INDEPENDENT ADVISORY PANEL FOR UNDERGROUND MINING

**TAHMOOR SOUTH
LONGWALLS S1A – S6A
EXTRACTION PLAN**

August 2022

Figure 2. Mine plan showing heritage sites (source: Tahmoor presentation on 19.07.22)

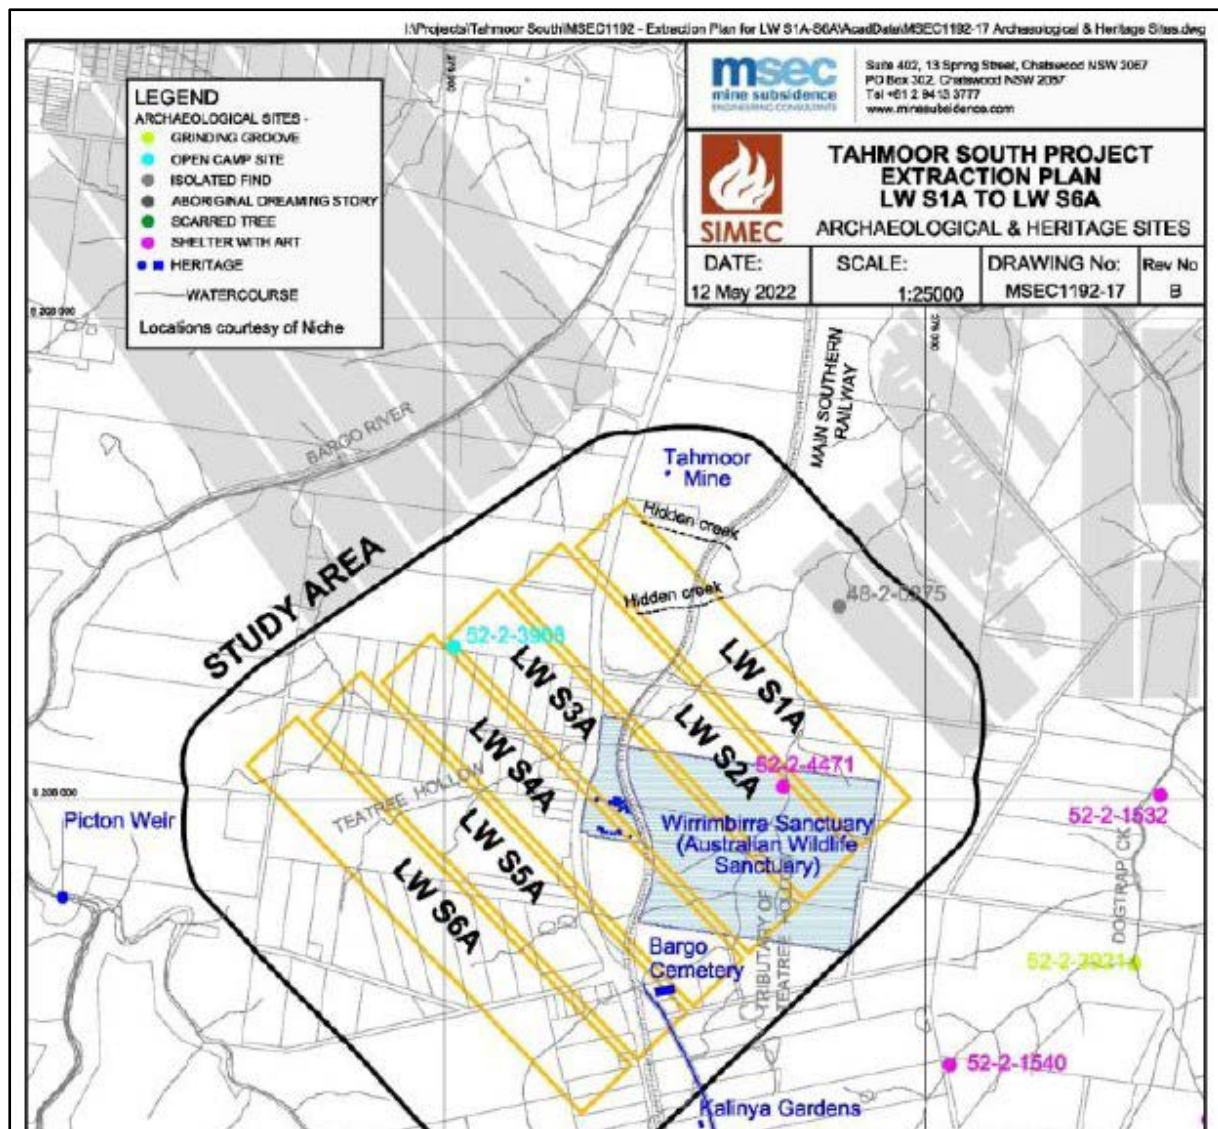
The location of this heritage site relative to the proposed mine plan is shown in Figure 2. The site location is marked on the boundary between LWS1A and S2A, marked as site 52-2-4471.

Given the location of this shelter above the panel edge of LWS2A, it will clearly be subject to subsidence effects including vertical subsidence, tilt and tensile strain – all of which have the potential to induce adverse impacts such as those noted above. Such impacts would then result in potential damage and/or loss of the rock shelter. Under the Development Consent conditions, this would then account for the 10% limit of impact to the total of 19 rock shelters, meaning that no further rock shelter impact would be permitted across the subsequent longwall B panels further to the south. The nature, quality and locations of the other 18 rock shelters is not known by the Panel.

It is recommended that subsidence impact mitigation measures be considered, and a mitigation plan developed for implementation in conjunction with the rock shelter above the boundary between LWS1A and LWS2A in order to minimise the risk of adverse impacts to this rock shelter.

The above recommended mitigation plan should be developed in conjunction with and informed by a broader assessment of the relative merits and value of all of the 19 rock shelters, in order to prioritise which 18 of these 19 (as a minimum) need to be protected.
